AGENDA

DEVELOPMENT DETERMINATION PANEL MEETING

ITEM 3.1	MOD2020/0062 - 31 VICTORIA PARADE, MANLY - MODIFICATION OF DEVELOPMENT CONSENT DA384/2009 GRANTED FOR ALTERATIONS AND ADDITIONS TO AN EXISTING FOUR 4 STOREY RESIDENTIAL FLAT BUILDING
REPORTING MANAGER	Rodney Piggott
TRIM FILE REF	2020/321761
ATTACHMENTS	1 Assessment Report 2 Site Plan & Elevations

APPLICATION FOR MODIFICATION ASSESSMENT REPORT

Figure 2: Comparison of height with surrounding buildings. (Source: Platform Architects Plan, Streetscape Rev A, 1/5/220)

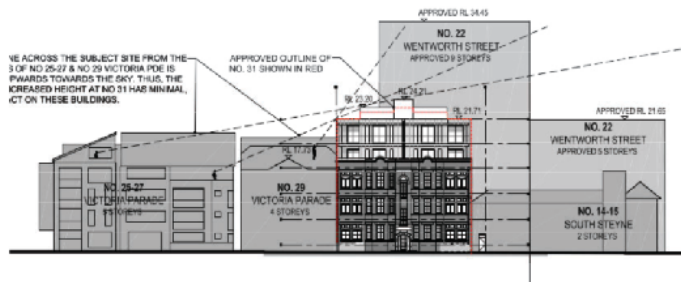
The additional building height is considered a minor area and is consistent with the height of surrounding buildings, particularly as the rear neighbouring site of 22 Wentworth Street (Royal Far West) is proposed to be a 9 storey development. See Figure 2 below.

The modifications to the building height are considered consistent with the approved development, and not inconsistent with the prevailing building height surrounding the site or the desired future character of the locality.

Figure 3: Additional building height variation shown in blue.

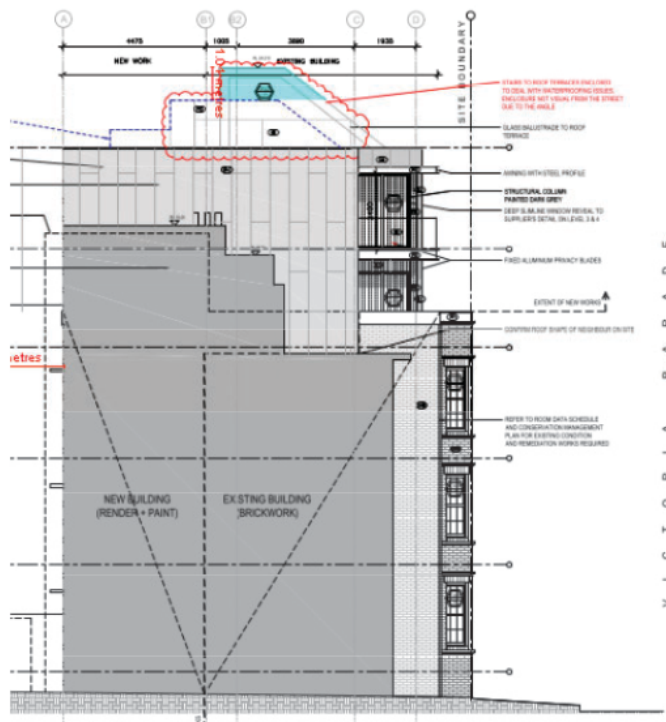
The additional building height non-compliance is of the stairwell roof is located within the building footprint, approximately 4.5m from the front setback, and is relatively minor in size when compared to the entire built form and surrounding area. See Figure 3 below.

The proposed roofing and privacy walls within the roof terrace areas will provide an appropriate visual presentation, minimises amenity impacts to the neighbouring sites, and will continue to be a similar representation of the existing approved residential flat building when viewed from the Victoria Street and surrounding sites.

Figure 4. Amended elements shown in pink within the existing approved building footprint.

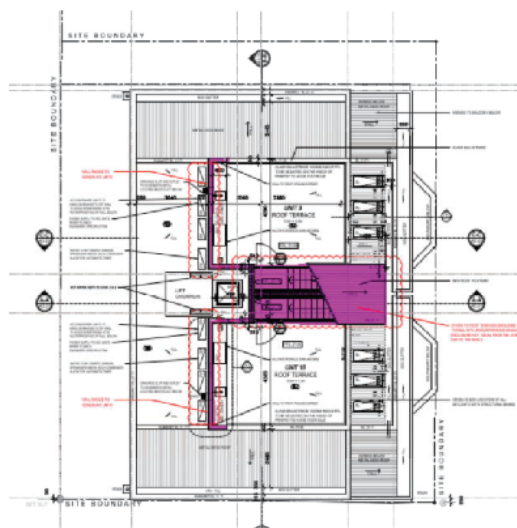
The proposed modifications include new works (including the enclosure of the access stairs, and increase in the height of the privacy walls on the roof terrace) which will sit within the approved setbacks for the proposed residential flat building. See Figure 4 below.

Whilst there is no change to the proposed setbacks of the privacy walls, and enclosure of the access

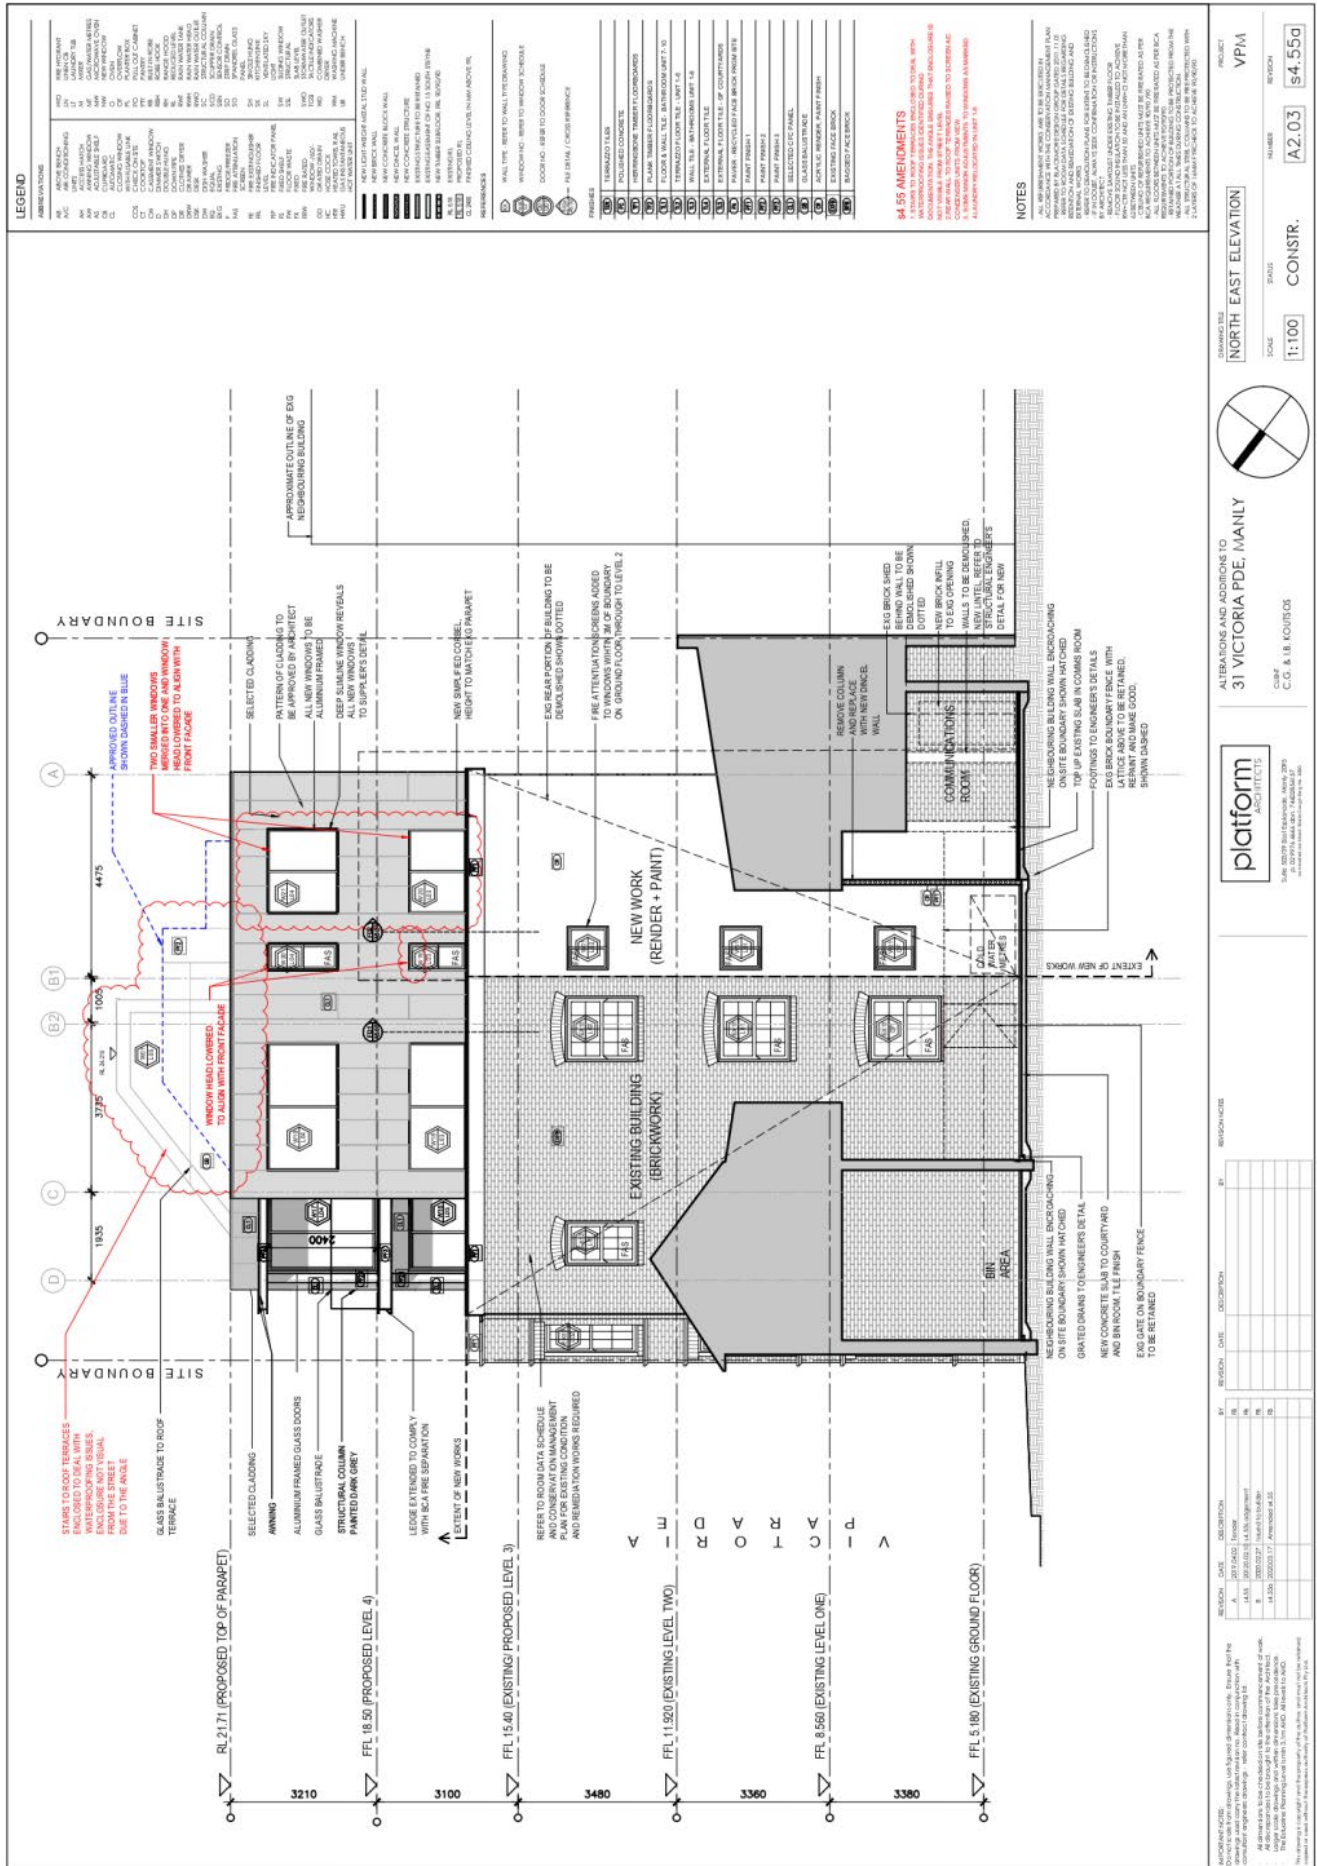
The proposed metal material for the Front Door is not approved.

The Front Door materials must remain as the previously approved timber Front Door. All plans are to be amended to remove the reference to the metal Front Door and replaced with the reference to the previously approved timber Front Door.

Details demonstrating compliance are to be shown on the construction certificate plans to the satisfaction of the Certifying Authority.

Figure 1 –Building Height Encroachment shown in section

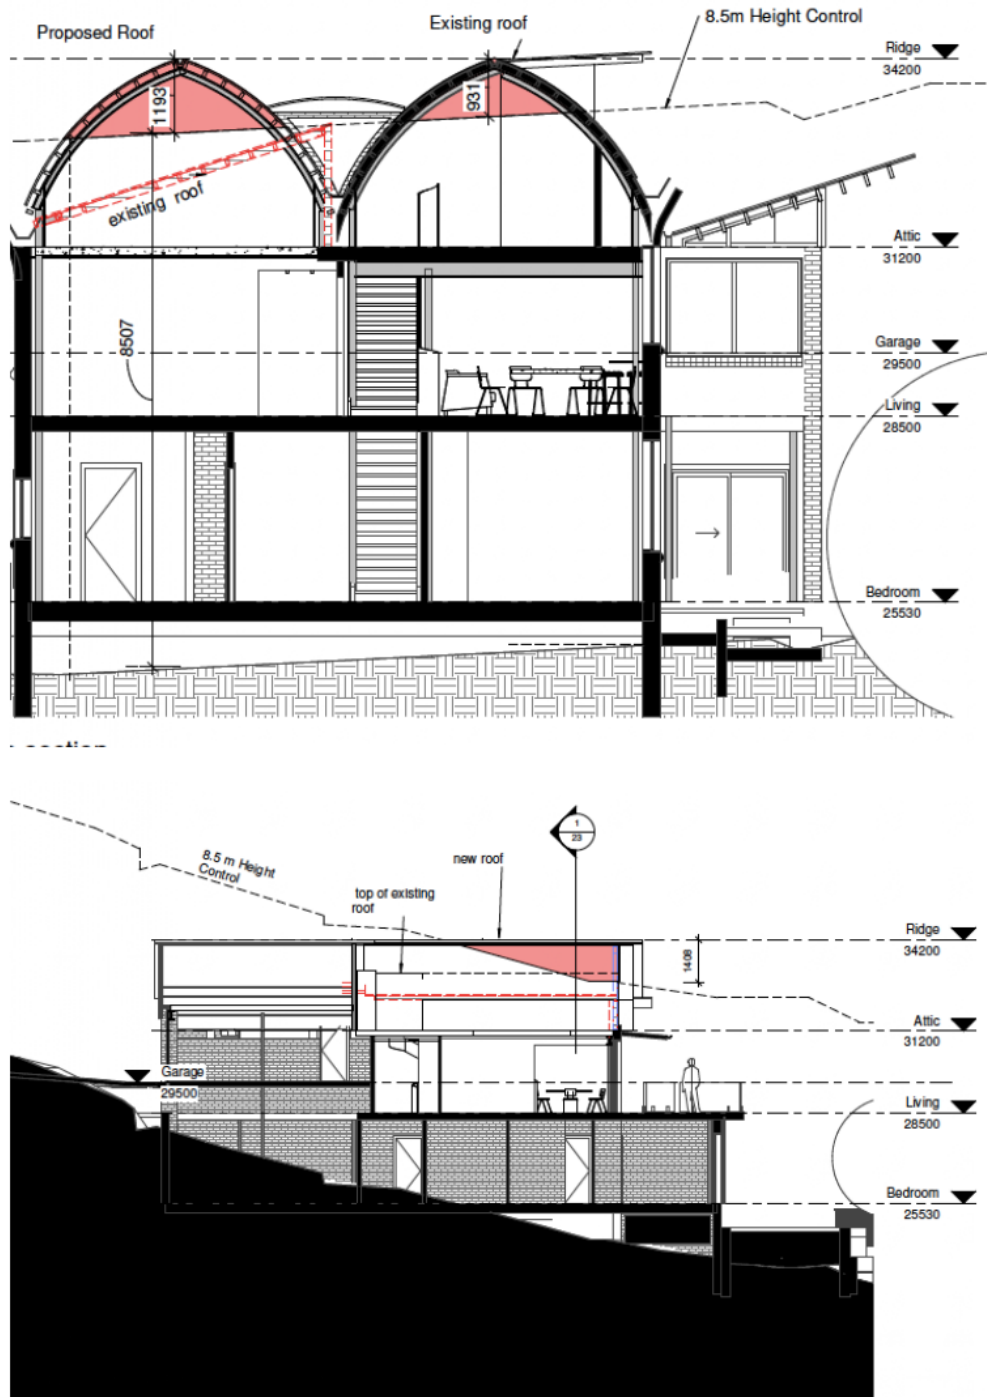
The greatest building height encroachment arises from the proposed apex of the roof as shown on the drawings. An extract of the drawings is provided in Figure 1 and Figure 2. The apex of the modified roof is located away from the side boundaries. The shape, height and form match the existing and distinctly shaped vaulted roof forms present on the dwelling. As shown in the Figures below, the new modified roof is to be a continuation of the existing roof. Therefore, to ensure architectural integrity, the same ridgeline RL must be carried through. As the roof reaches the rear of the dwelling where the land below falls away, the height exceeds the maximum 8.5 metre limit however it is consistent with the existing height of the vaulted roof of the dwelling.

The roof contributes to the character of this part of Palm Beach and the colours, materials and form are recessive in nature and reduce the prominence of the roof when viewed from afar. The proposal will integrate into the existing roofscape. The overall generally modest extent of height exceedance is illustrated in the drawing shown in red below, in Figures 1 and 2.
